**DRAFT QRS AND TDS OF MODULAR KILL HUT/ SHOOT HOUSE WITH ADVANCED TARGET SYSTEM**

विषय:- **FORWARDING OF DRAFT QRs AND TDs OF KILL HUT/ SHOOT HOUSE  
WITH ADVANCED TARGET SYSTEM FOR SUGGESTION/ COMMENTS**

Please refer to your office letter No. P/604/2018/Kill Hut/Prov (Ord)/HQ NSG/1708 dated 01.07.2022. Para wise comments on draft QRs/TDs on the subject are as under:

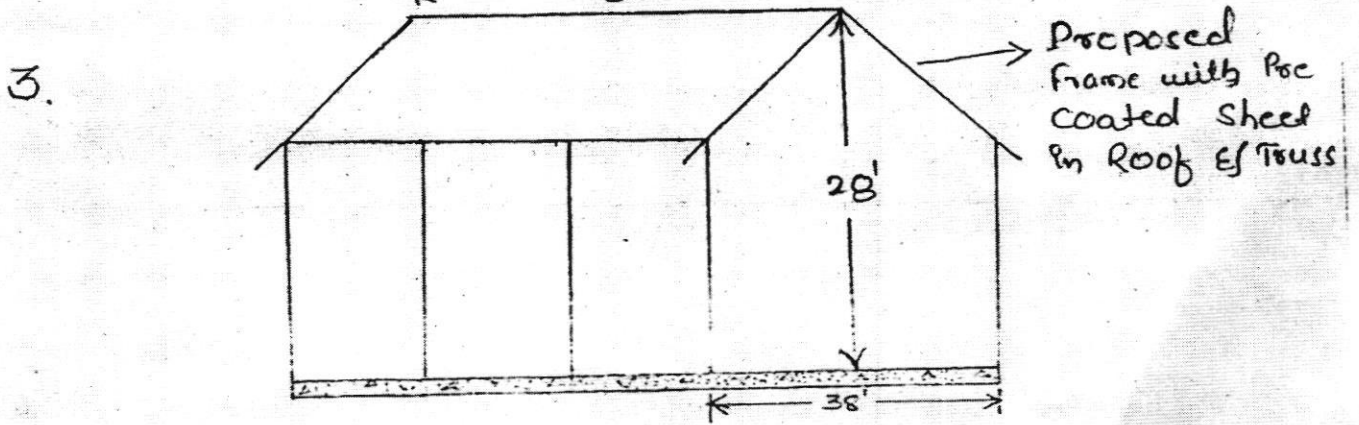
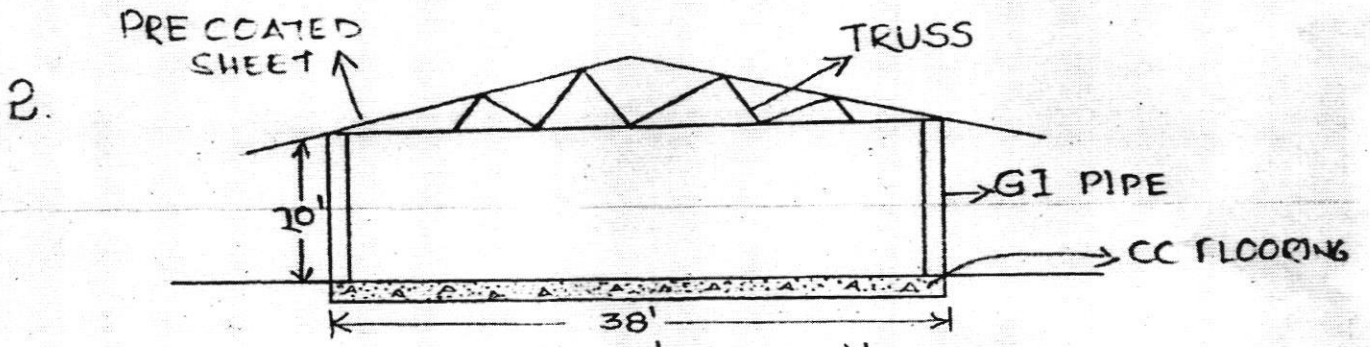
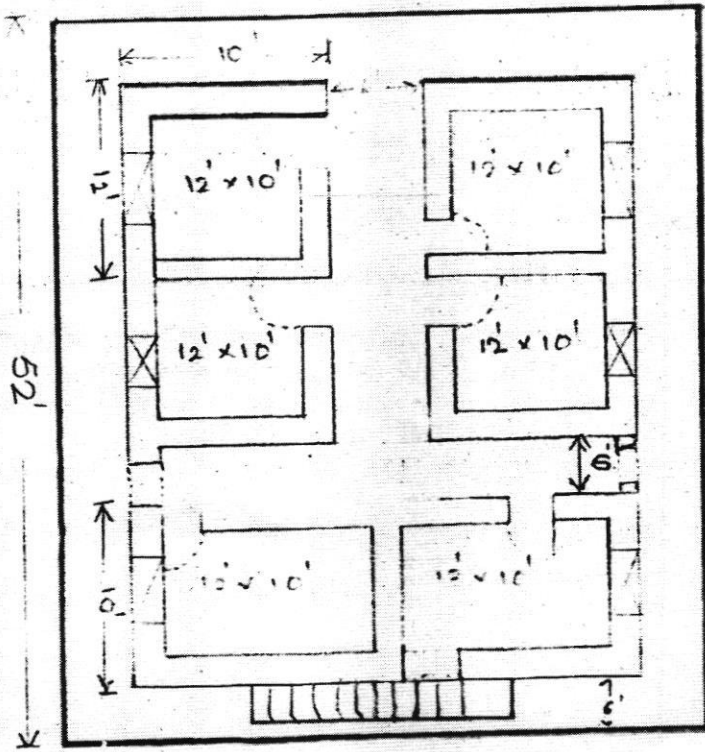
1. As per General parameter at S. No. 1 para (d) of specification, stairway is also required in the Modular Kill Hut. Sketch to be modified accordingly.
